# Technical BULLETIN

## SAFETY RECALL

### CERTAIN 2019~2020 MTT9GT (TRACER GT), 2019 MXTGTKL (NIKEN GT), 2017~2020 MT10, 2014~2020 XTZ12 (SUPER TÉNÉRÉ), 2013~2020 FJR13, 2018 XV19B (STAR ELUDER) AND 2018~2021 XV19 (STAR VENTURE) MODEL MOTORCYCLES

#### FACTORY MODIFICATION CAMPAIGN – Brake Switch Malfunction

FRONT BRAKE SWITCH

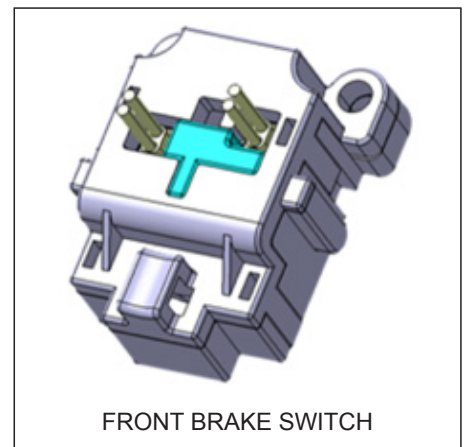
In affected motorcycles, the front brake switch may fail due to increased internal resistance caused by silicon oxide. If this happens, the brake light may stay on constantly and/or the cruise control system, if it can be activated at all, may cancel unexpectedly, either of which could increase the risk of a crash with injury or death.

To correct this defect, Yamaha is initiating a Factory Modification Campaign. Affected units must have the front brake switch replaced with new one that was manufactured properly.

PREVIOUS  
(REPLACE)

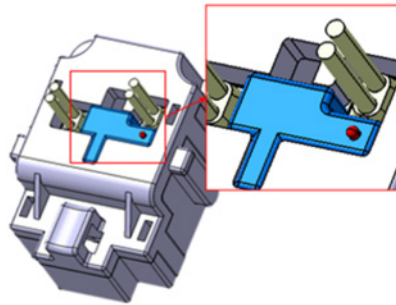
A new part identification mark is added on the back side of the switch:

NEW  
(COUNTERMEASURE)
